SAN FRANCISCO PLANNING DEPARTMENT

Discretionary Review Full Analysis

Date: October 27, 2011
Case No.: 2010.0801D, 2010.0858D and 2010.0860D
Project Address: 183, 187 and 191 Brewster Street
Permit Application: 2006.09.25.3191, 3192 and 3193
Zoning: RH-1 (Residential House, One-Family)
Bernal Heights Special Use District
40-X Height and Bulk District
Block/Lot: 5577/009, 010 and 011
Project Sponsor: Jane Viltman for 183 Brewster Street
139 Casitas Avenue
San Francisco, CA 94127
AND
Alice Barkley for 187 and 191 Brewster Street
121 Spear Street, Suite 200
San Francisco, CA 94105
Staff Contact: Corey Teague – (415) 575-9081
corey.teague@sfgov.org
Recommendation: **Do not take DR and approve the projects as proposed.**

SITE PLAN

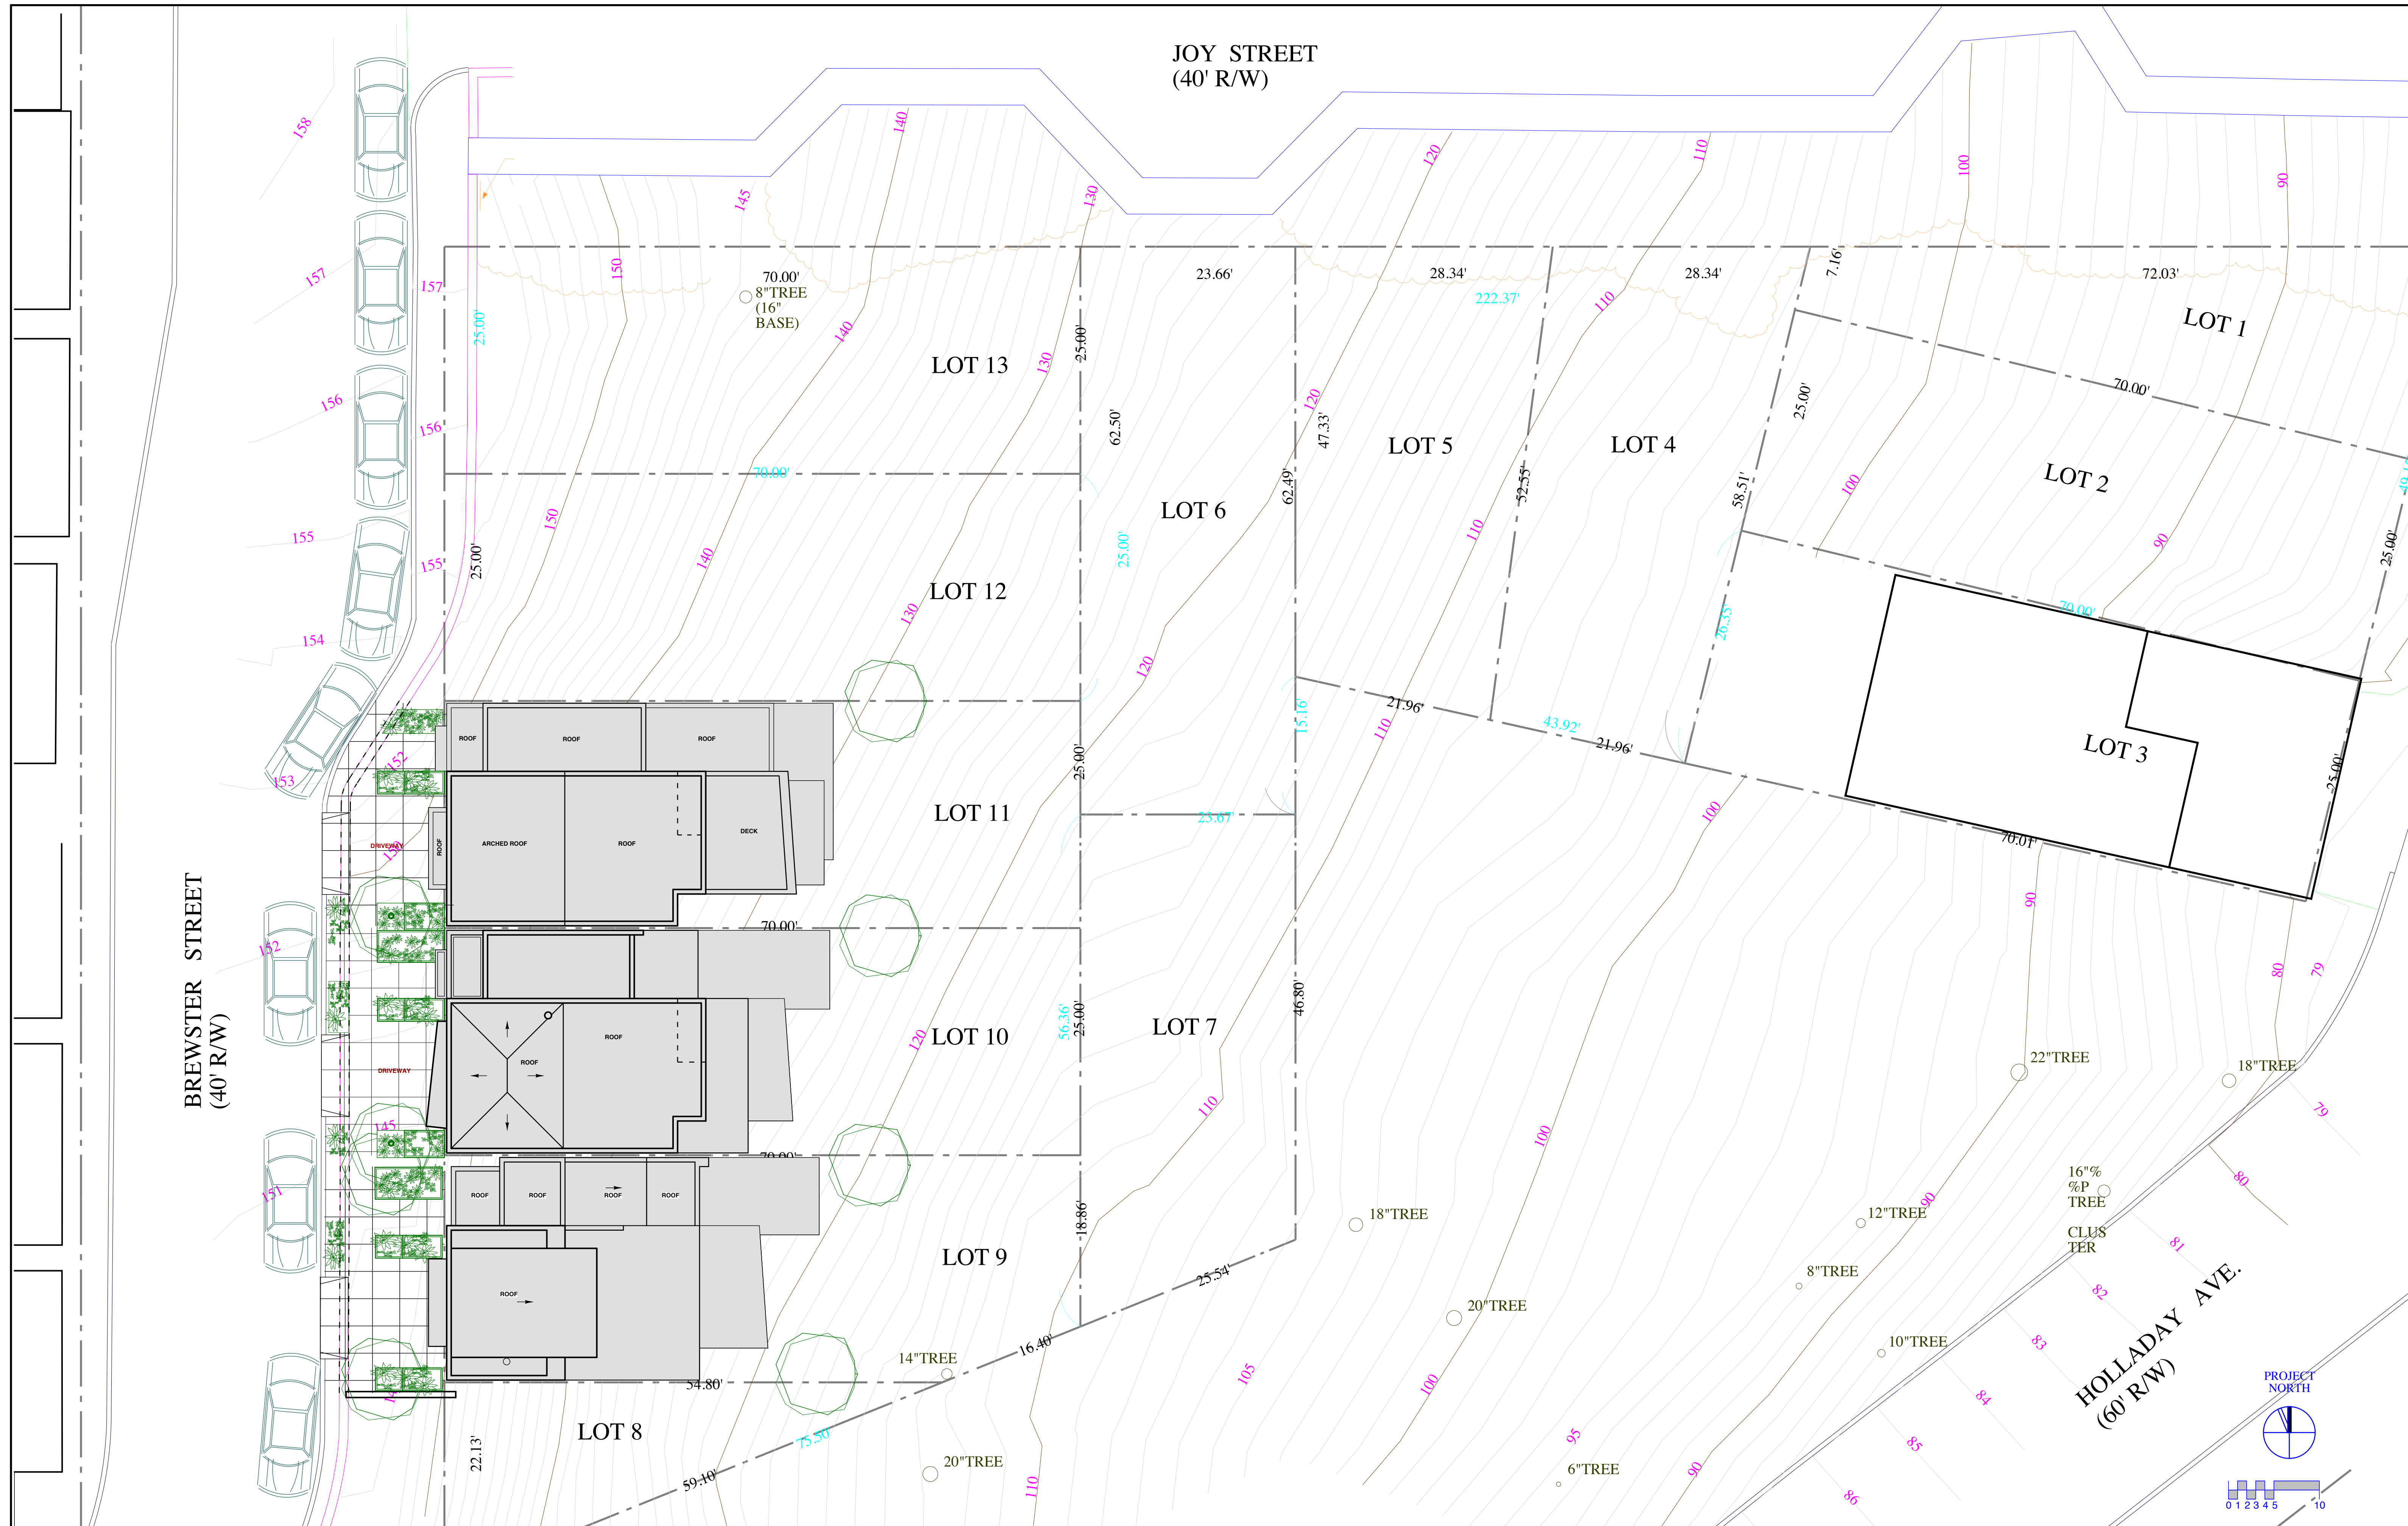
1. The curb cut width has been decreased at all five lots, to 9'-0". (Site Plan sheet A0.02)
2. The curb cuts for lot 9, 10,11 and 13 have been repositioned relative to each other in order to maximize the opportunity for parking in between them. (Site Plan sheet A0.02)

4. **Street parking space at corner of Joy and Brewster Street.** Our revised drawing A0.02 has removed the implied stall previously shown at that corner.
